Version 4

Safety Recall: 2019 RLX Fuel Pump Motor

Supersedes 20-028, dated June 19, 2020, to revise the information highlighted in **yellow**.

Under REPAIR PROCEDURE, steps 7, 9.1, 9.2, 9.3, 9.4, and 10.1 were revised.

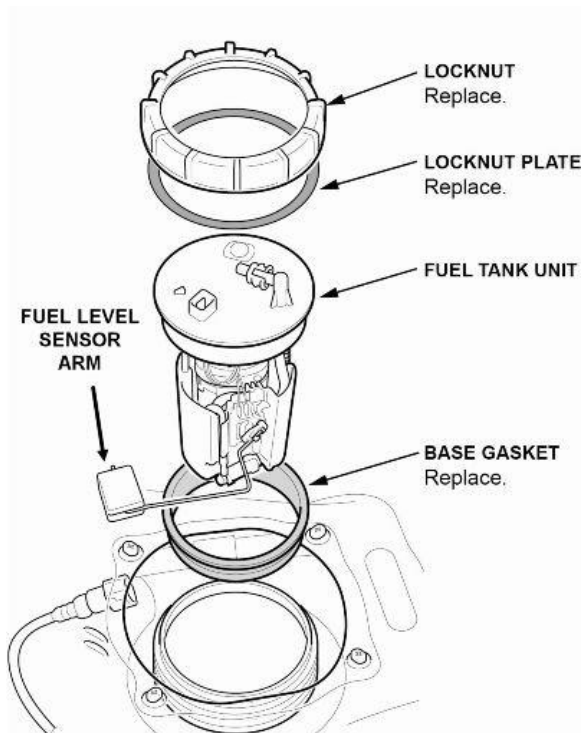
7. Remove the fuel tank unit locknut, and remove the fuel tank unit.

- After unlocking the fuel tank unit cam lock ring, clean the top of the fuel pump flange and adjacent areas to make sure it's free of dirt, dust, and debris.
- Make sure not to bend or twist the fuel level sensor arm excessively.

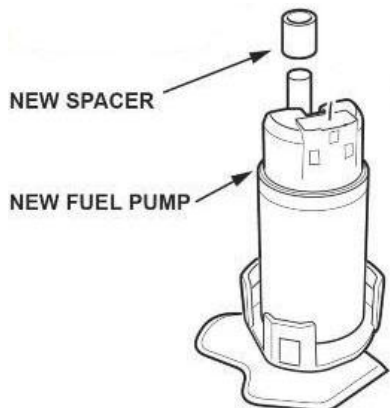
- 9.1. **Install the new spacer on the new fuel pump motor.**

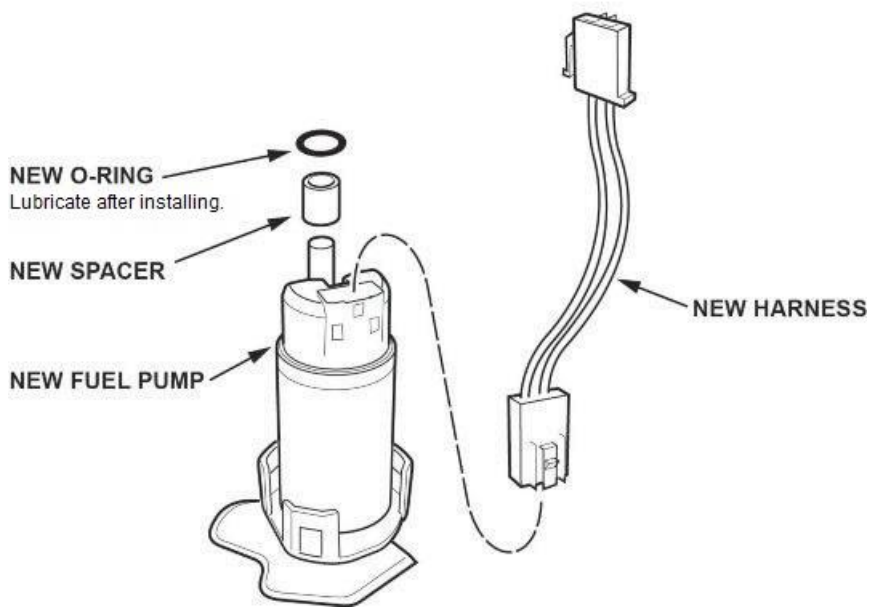
9.2. Install the new O-ring, then lubricate the outside edge of it, using only clean engine oil.

NOTE: Do not pinch the O-ring during installation.

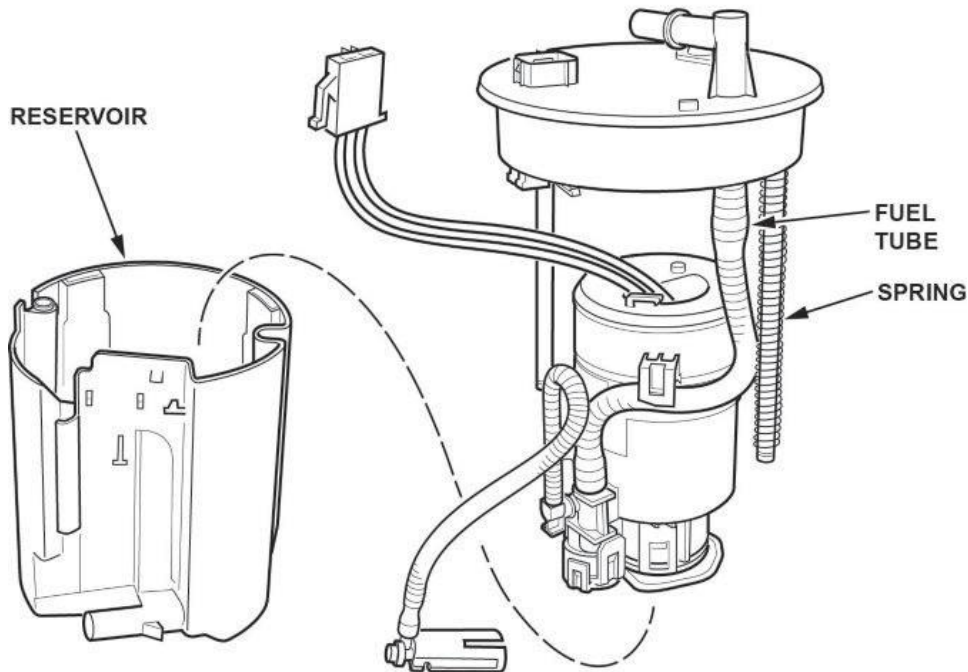
9.3. Install the new harness and make sure the connection is secure and the connectors are firmly locked into place.

9.4. Place the fuel pump on a bench, then install the filter to the fuel pump.

NOTE: If the fuel pump does not engage into the fuel filter and re-insertion is necessary, confirm that the O-ring is seated on the fuel pump before repeating installation.

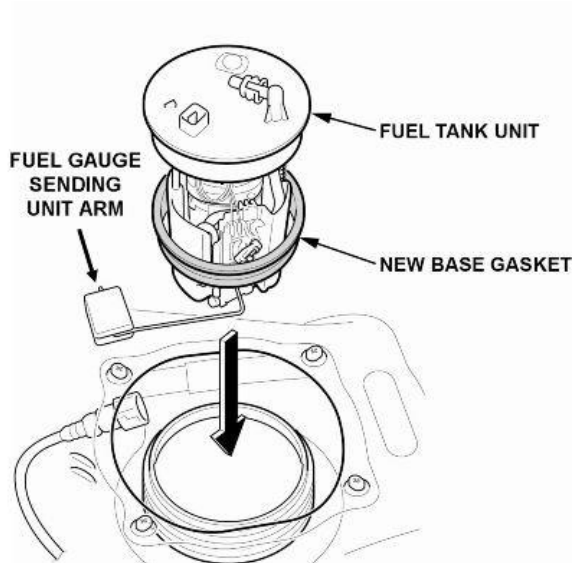
10.1. Partially insert the fuel tank unit into the fuel tank with a new base gasket.

- Before installing the new O-ring, clean the fuel tank around the fuel pump opening where the O-ring will seat. The tank opening must be free of dirt, dust, and debris.
- Be careful not to damage the new base gasket.
- Be careful not to bend the fuel gauge sending unit arm.
- Do not coat the base gasket with any oil.
